Responses to Comments on
Draft Planning Statement (Issue 1)

Planning Statement

**S16 Planning Application for Proposed Minor Relaxation of Building Height and Plot Ratio
Restriction for Public Housing Developments near Tan Kwai Tsuen**

March 2023 (Issue 2)

ANNEX 2
MASTER LAYOUT PLAN FOR THE
BASELINE SCHEME

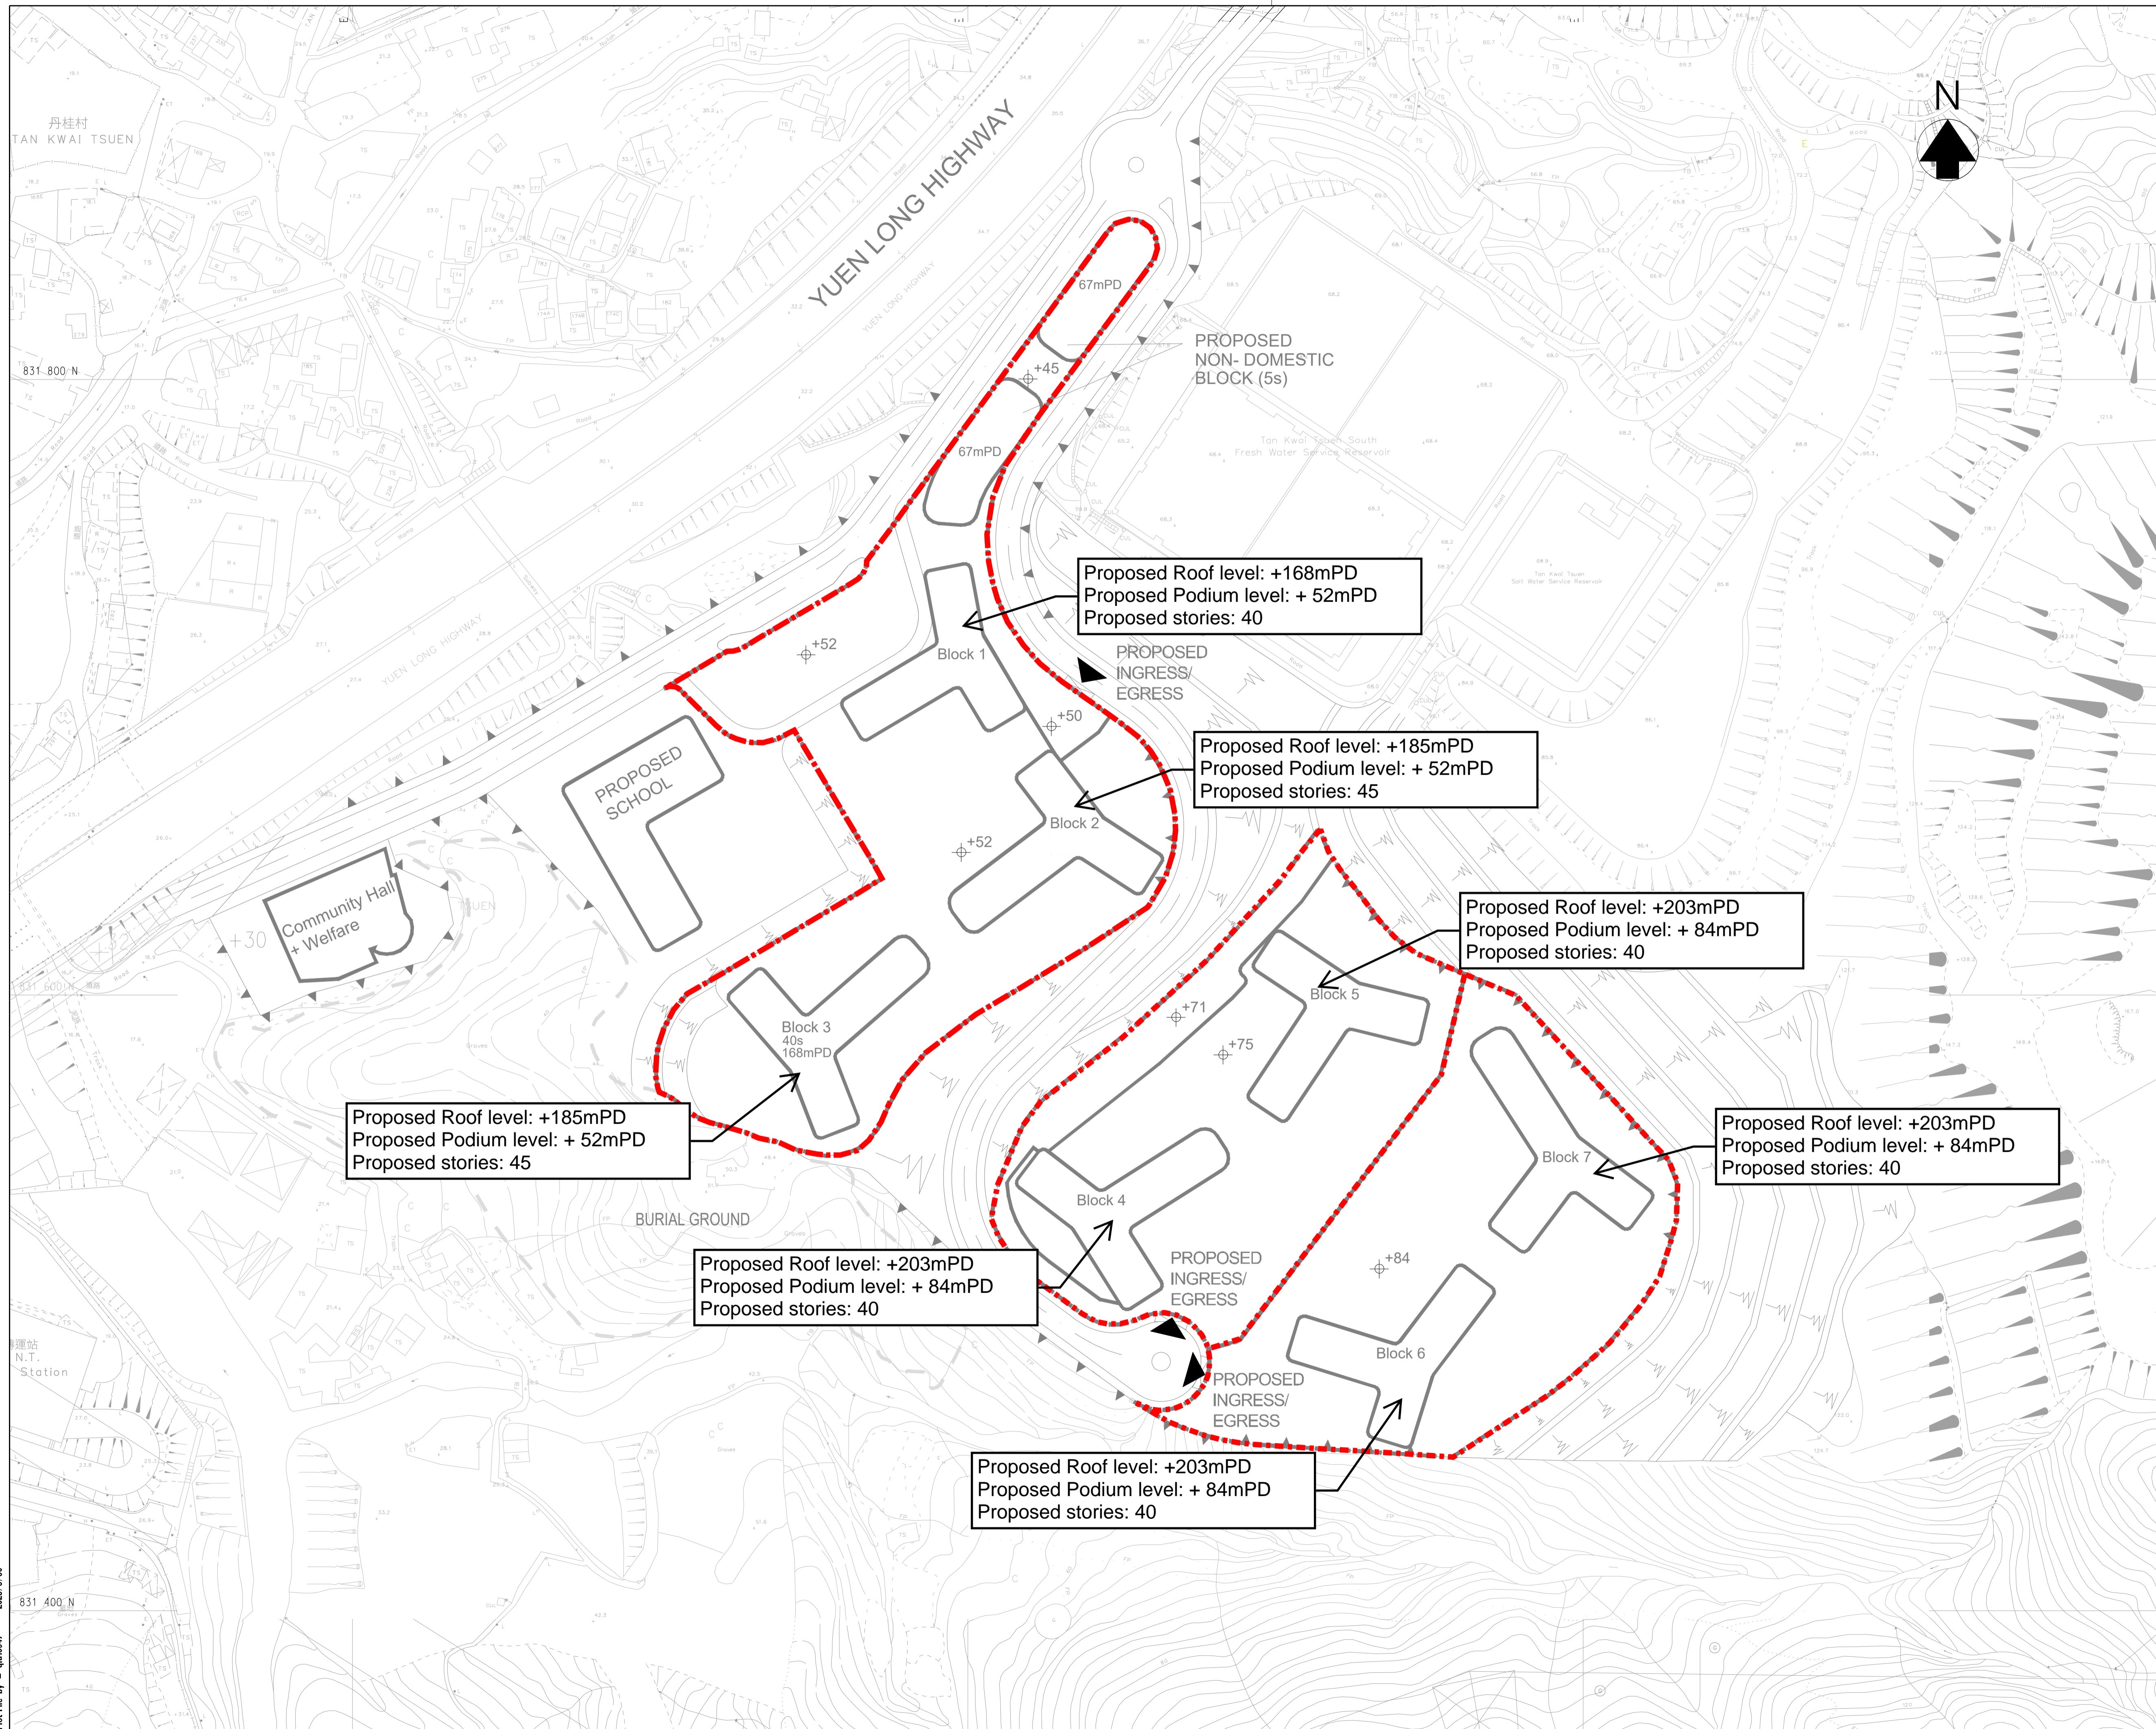
<p>10. Annex 2 MLP & Sections for the Conforming Housing Scheme – According to the air ventilation assessment in the form of expert evaluation (AVA-EE) (Section 1.4 & Figure 1.2 of Appendix D refer), it is stated that the conforming scheme (i.e. baseline scheme) is extracted from the AVA-EE under the Feasibility Study 2 in support of the previous rezoning amendments for the proposed development. However, there seems no indication of the source of the conforming scheme in Annex 2 of the PS and which is different from that of the AVA-EE in Appendix D. It is also noted that the conforming scheme of the AVA-EE in Appendix D adopts the one in the AVA-EE and visual impact assessment (VIA) under the Feasibility Study. Please rectify/clarify the conforming scheme.</p>	<p>Revised. Please refer to updated Annex 2.</p>
<p>11. As the analysis in the VIA and AVA-EE is formulated on the basis of the comparison between the proposed scheme and conforming scheme, to facilitate the processing of the application, comments on the VIA and AVA-EE are provided on the presumption that the conforming scheme of the AVA-EE in Appendix D should be adopted. Having said that, please clarify the extent and BHs of the podium structures of the conforming scheme and supplement in the PS, VIA and AVA-EE.</p>	<p>Revised. Please refer to updated Annex 2.</p>
